Lancaster County School District Amendment #1	Solicitation Number	202502	
		Solicitation Issue Date	07/30/24	
		Amendment Issue Date	8/12/24	
		Procurement Officer	Trevor Hammond, NIGP-CPP, CPPB (803) 416-8828	
		E-Mail Address	trevor.hammond@lcsd.k12.sc.us

DESCRIPTION: **Restrooms for BHS & LHS Baseball Fields**

Effective this date, this amendment forms part of the contract documents and modifies the original IFB

WATER & SANITARY SEWER DETAILS

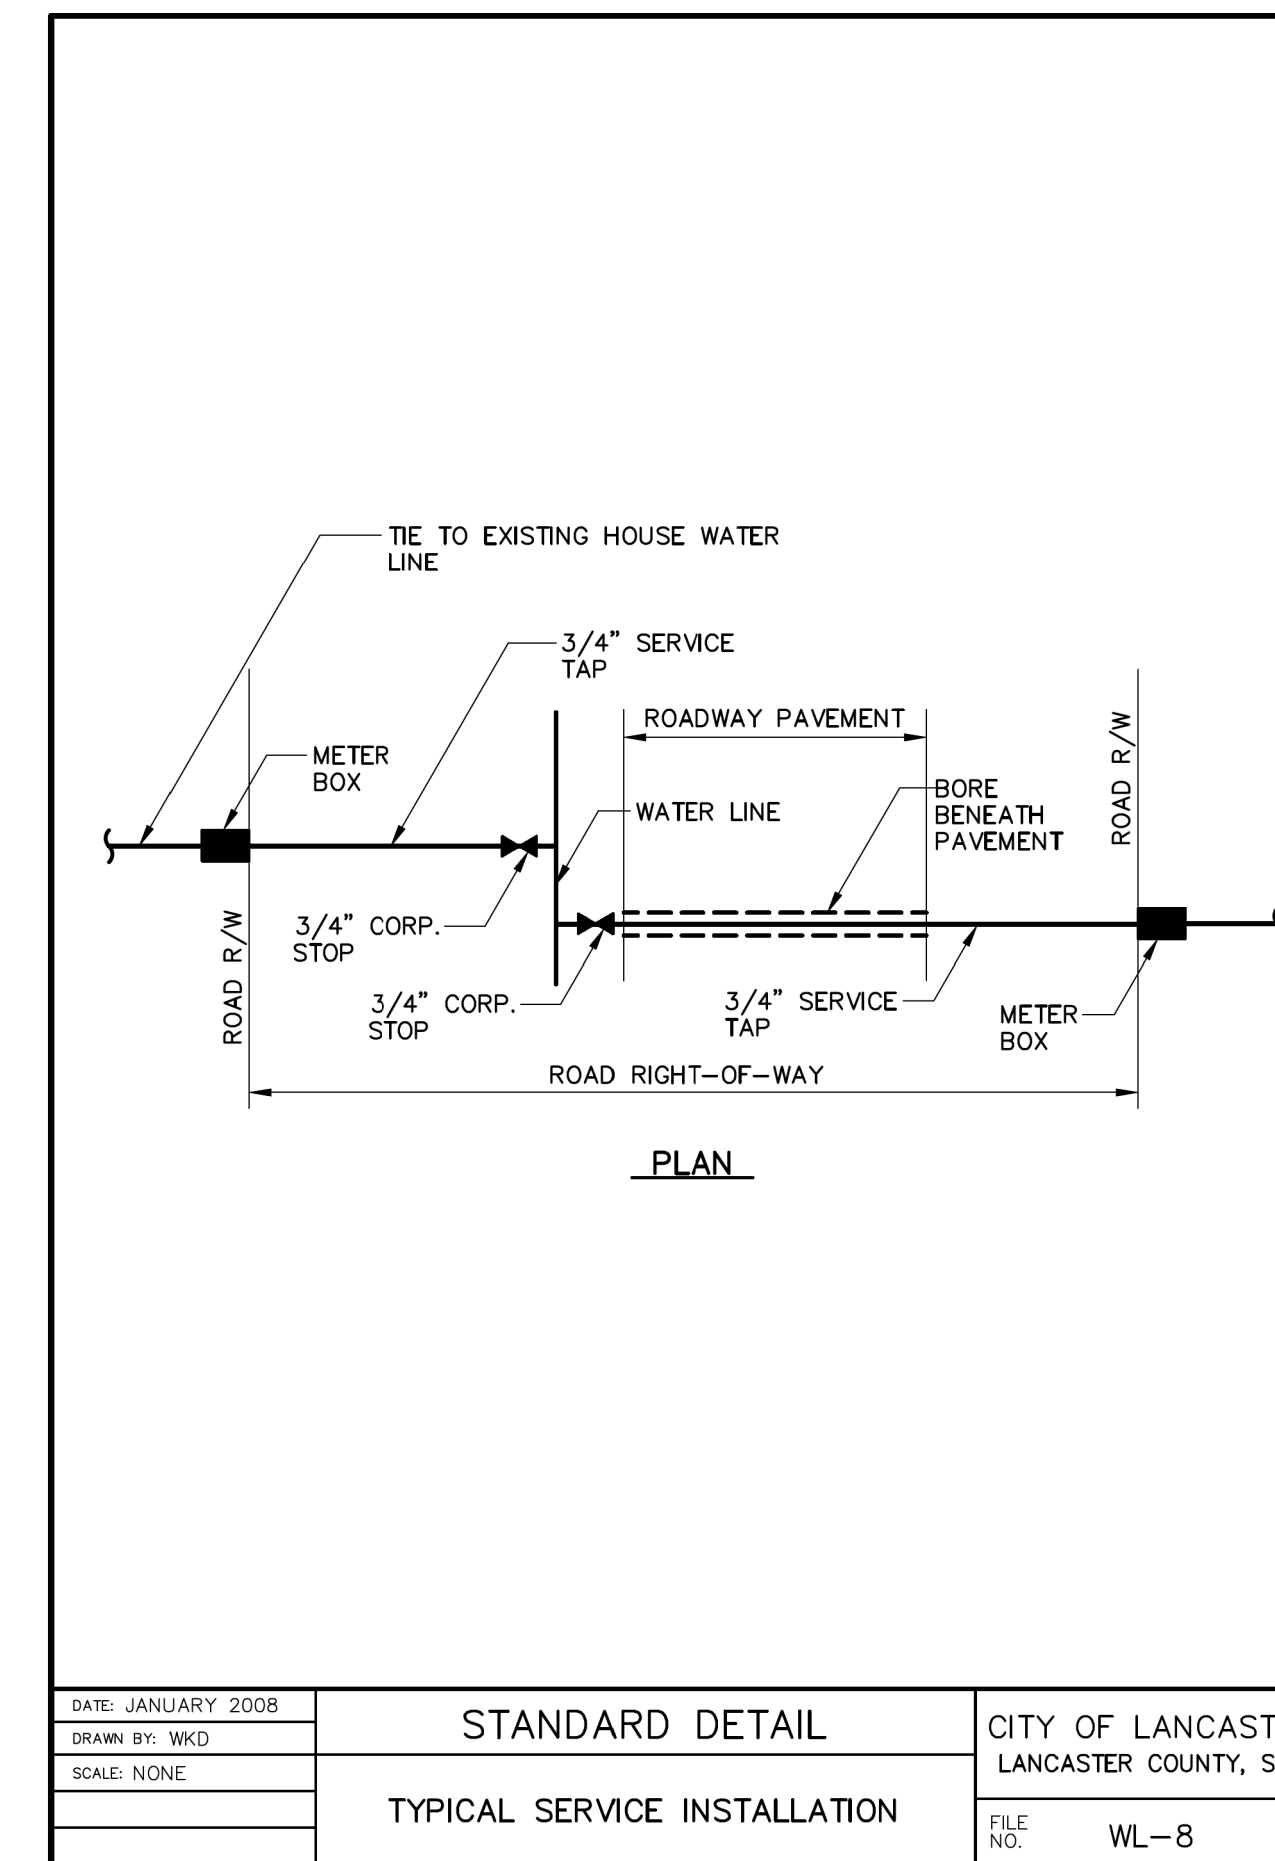
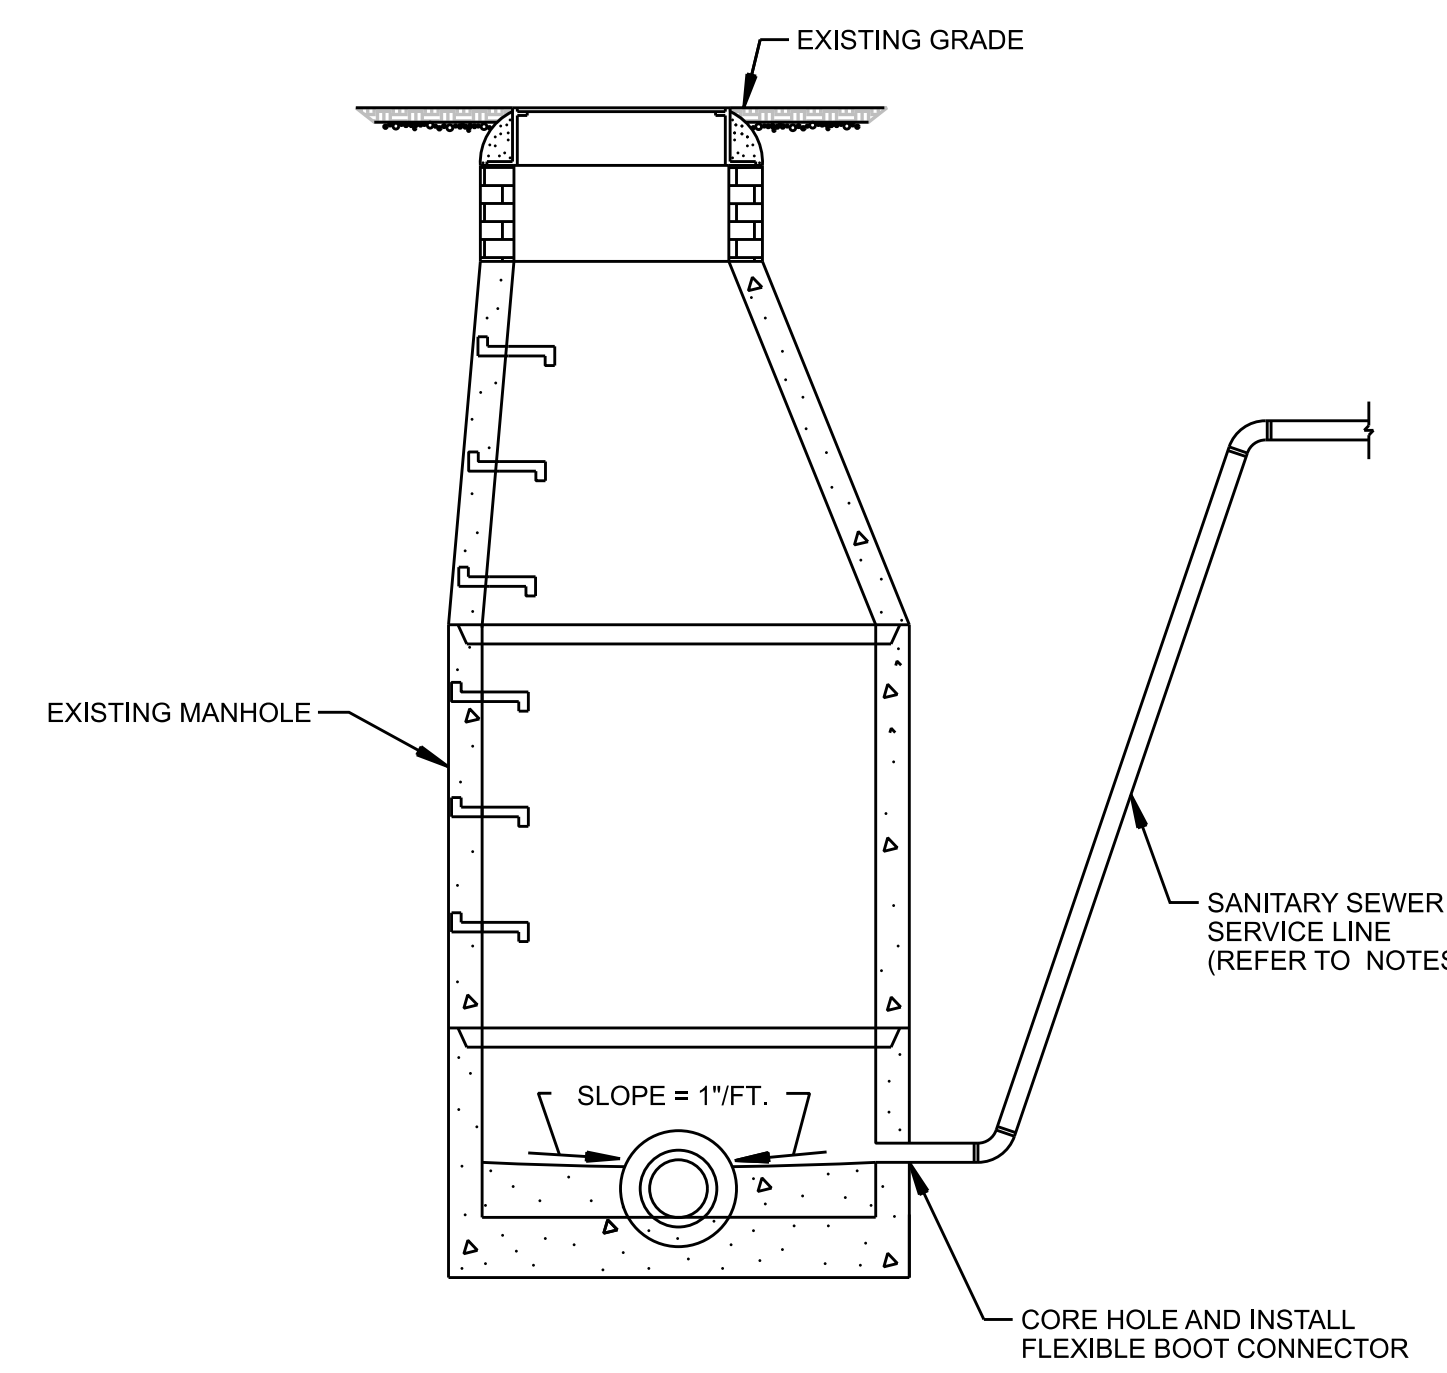
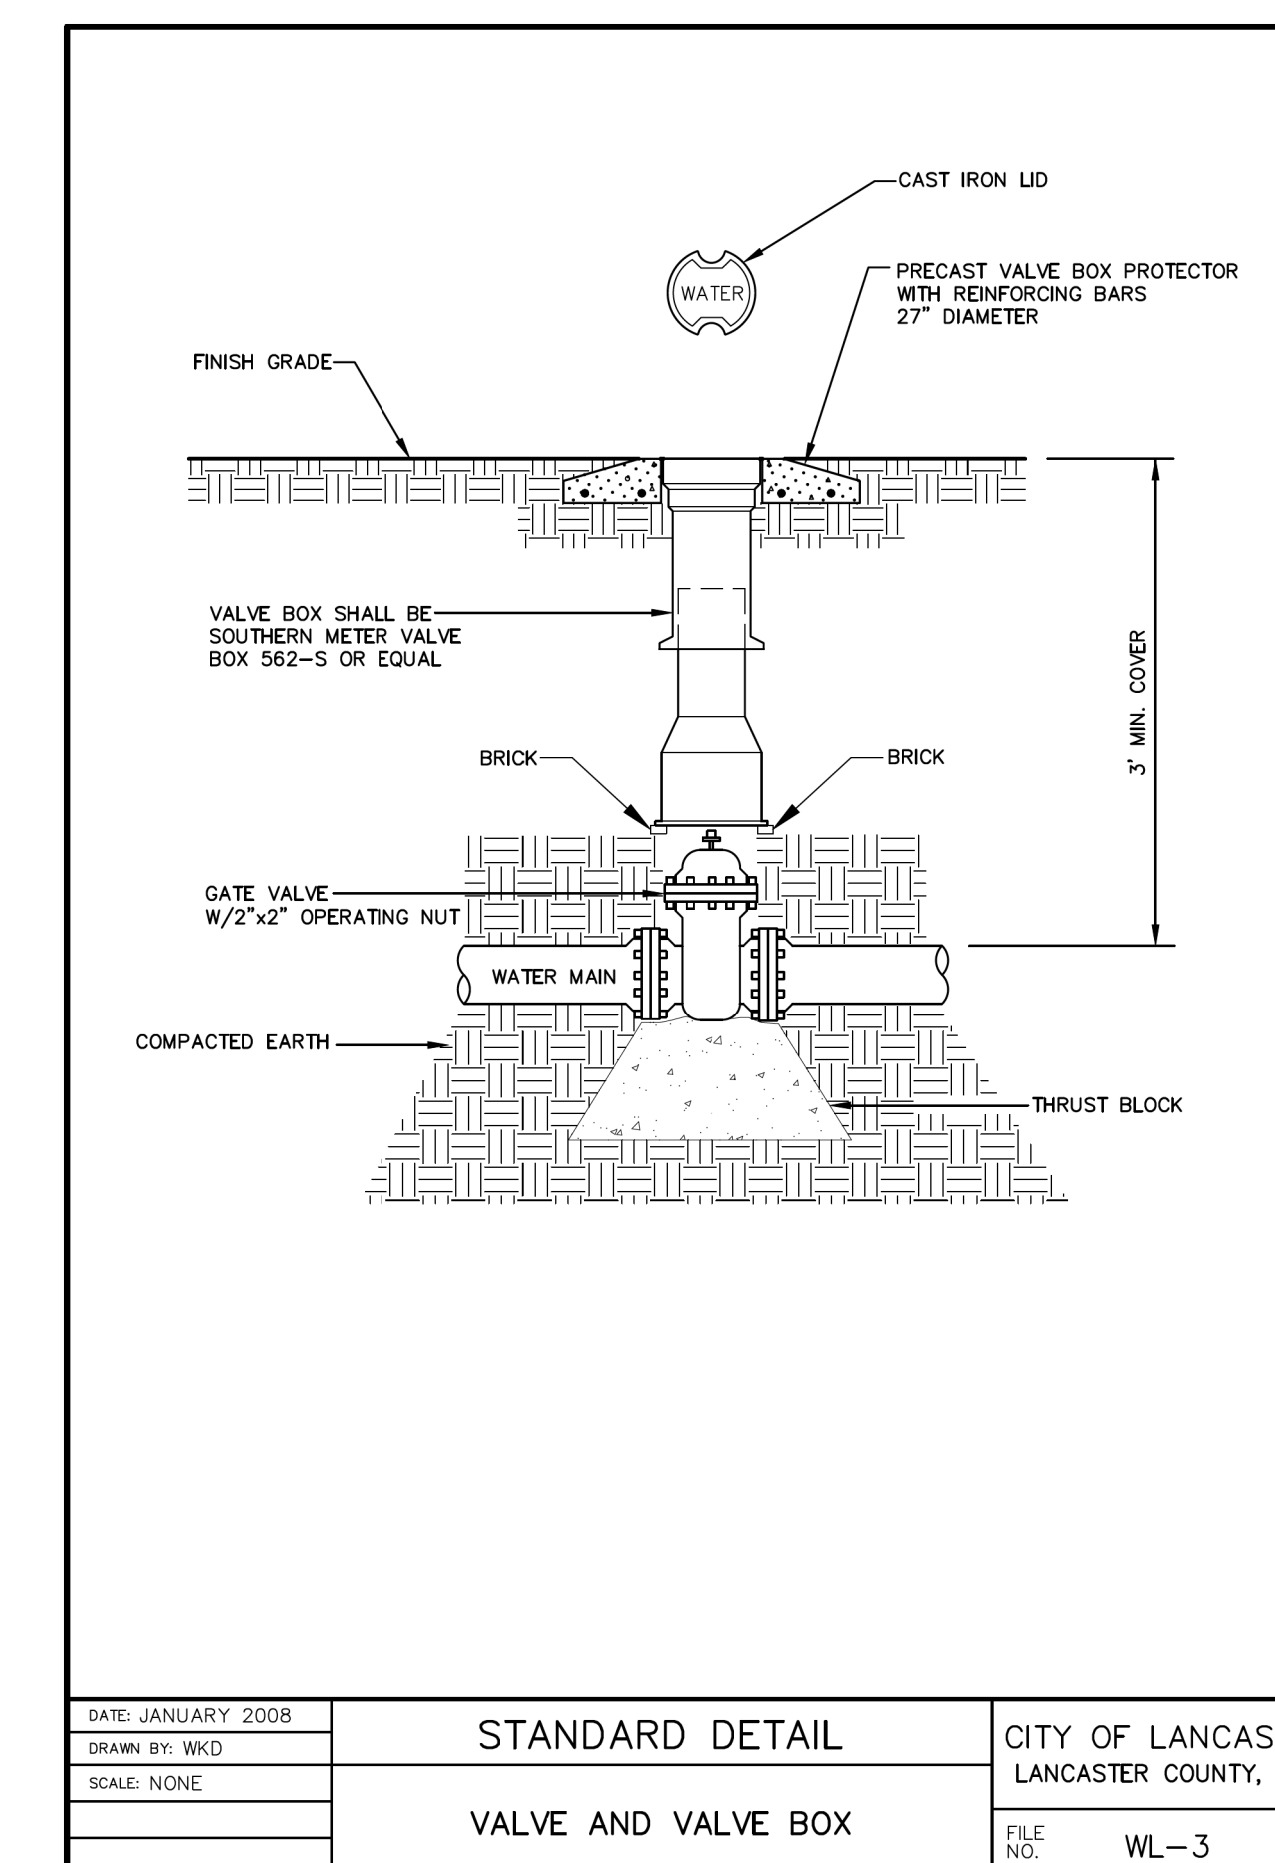
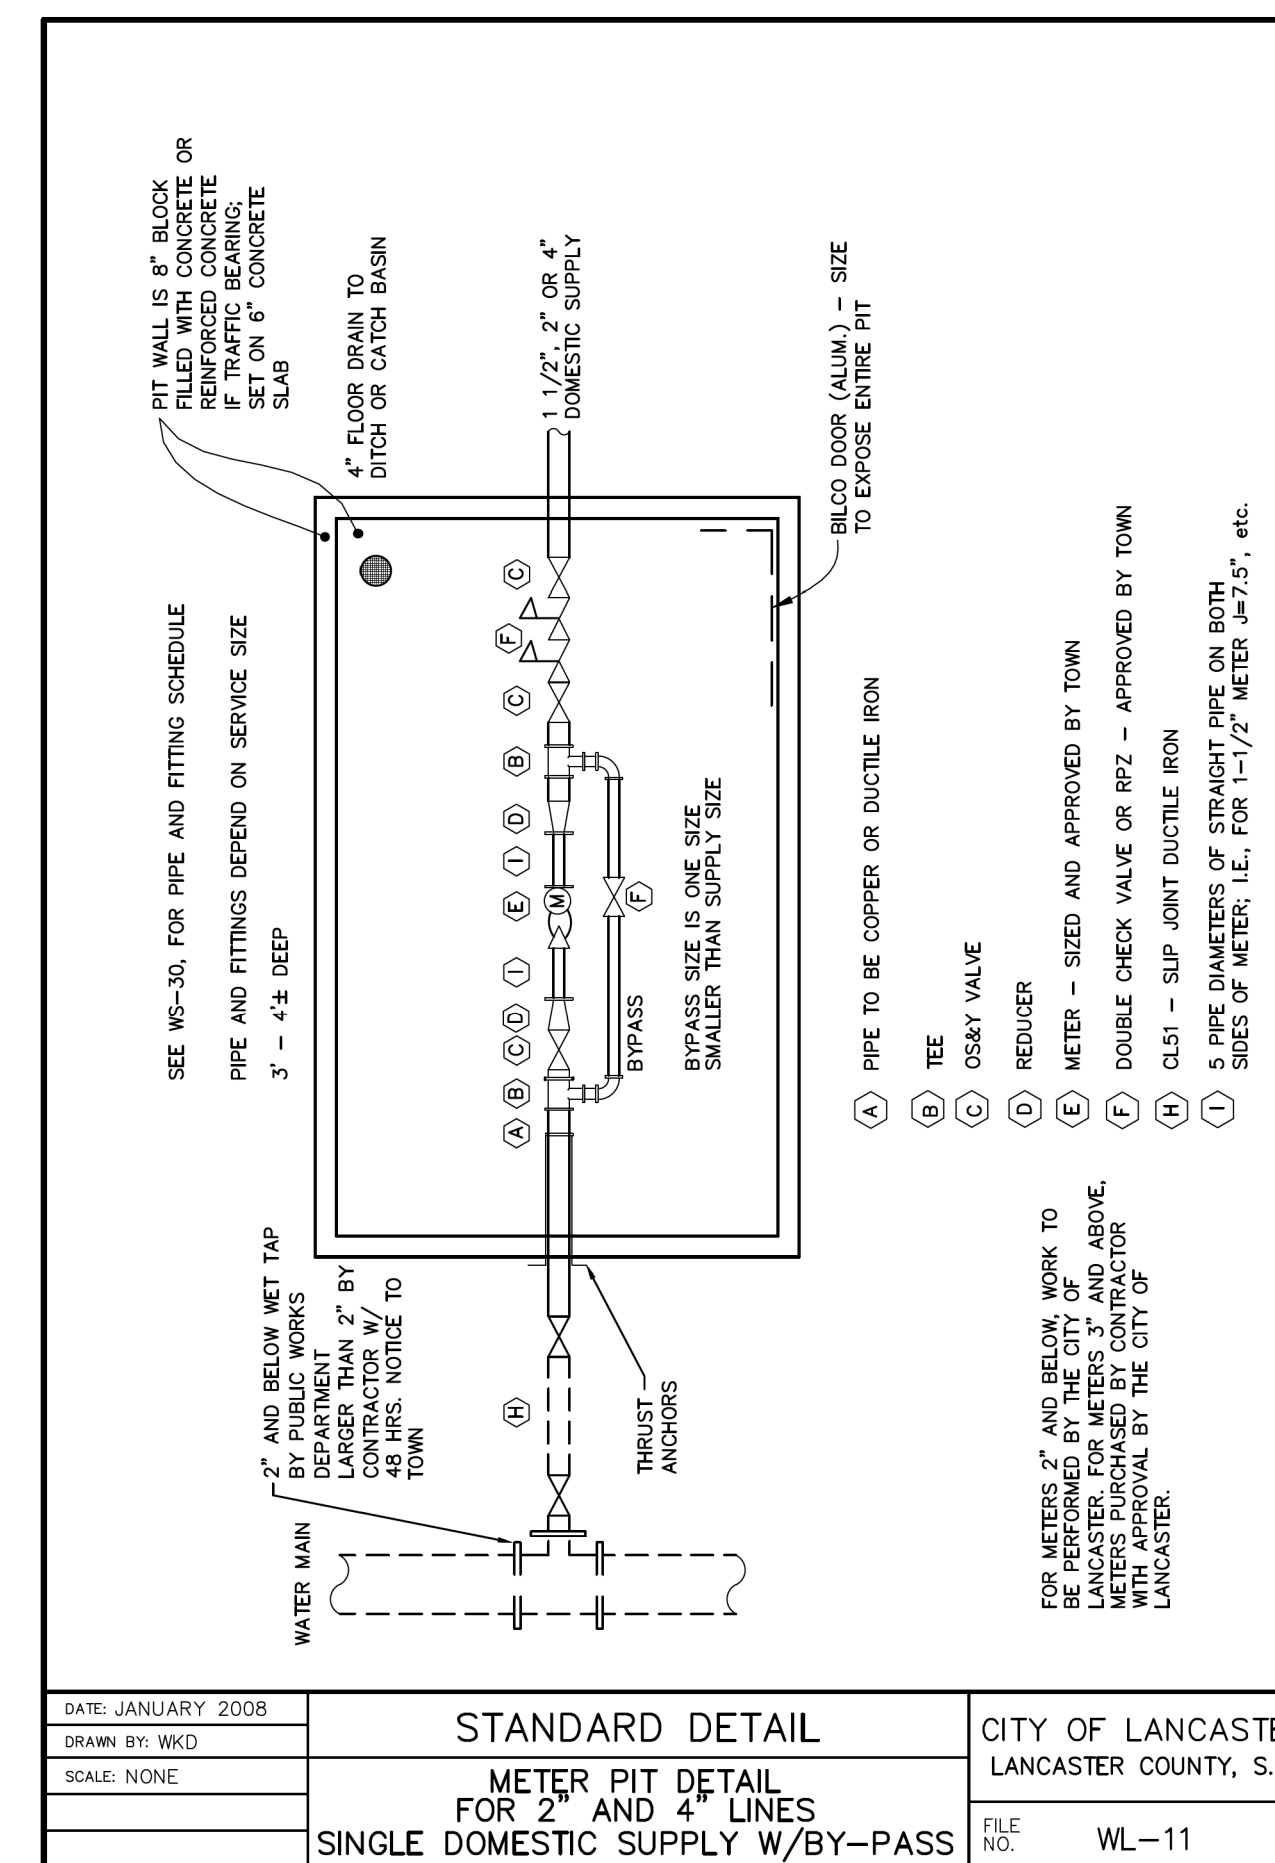
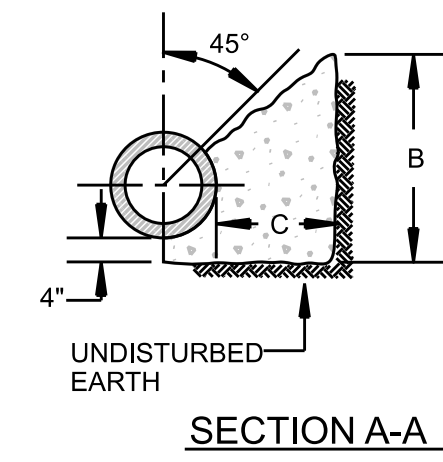
2. 2-inch compression fittings have been revised to 2-inch fittings with blocking.
- D. Replace sheet C601 with revised sheet C601 – Water & Sanitary Sewer Details, included in the Attachments.

1. 2-inch polyethylene C-901 water service line has been revised to a 2-inch PVC SDR-21 water service line.
 2. 2-inch compression fittings have been revised to 2-inch fittings with blocking.
